**Clinton Coal Gas Community Advisory Group Comments**  
***Comment Review Based on Final Release of EE/CA***

**Engineering Evaluation/Cost Analysis**  
**Part III – Remedial Alternatives Evaluation**  
**Clinton Coal Gas Site**  
**Clinton, Iowa**

**By**  
**TOSC Program**  
**Great Plains/Rocky Mountain Hazardous Substance Research Center**

January 17, 2002  
*Reviewed May 22, 2002*

Figure 1. Old sewer lines where contamination has been observed.

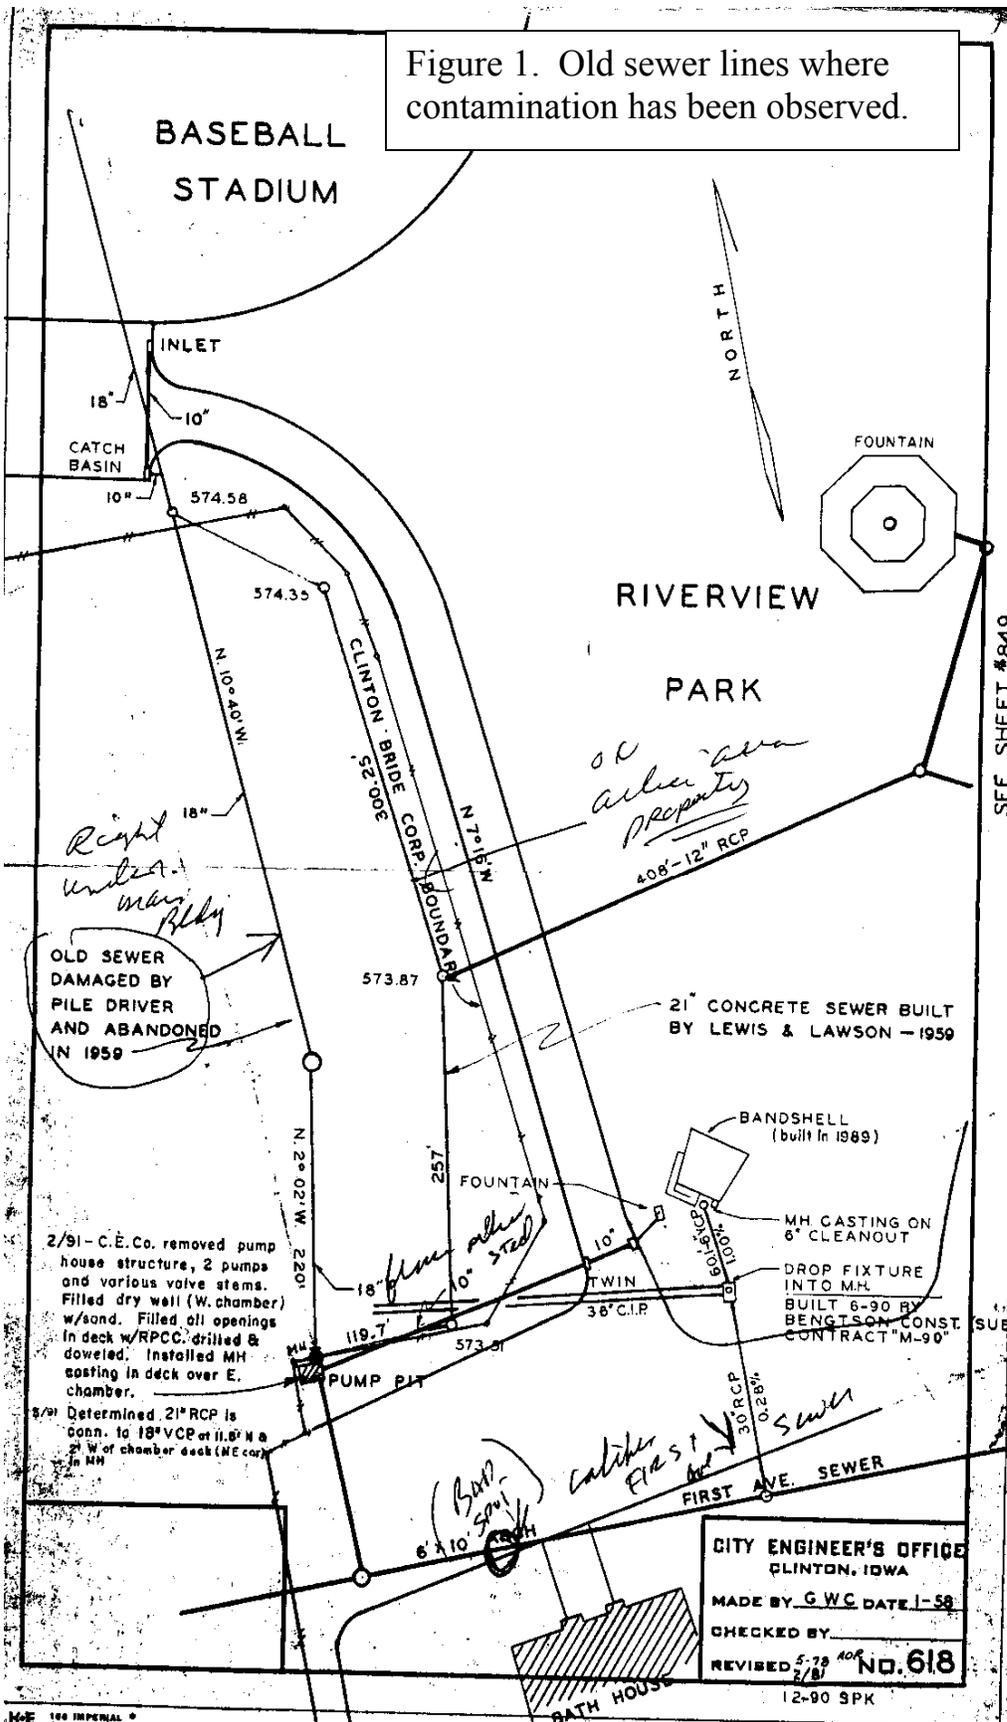
2) Contamination (freeproduct) in a city sewer at the site. There is contamination present in old sewer lines that have not been addressed in the EE/CA. See Figure 1.
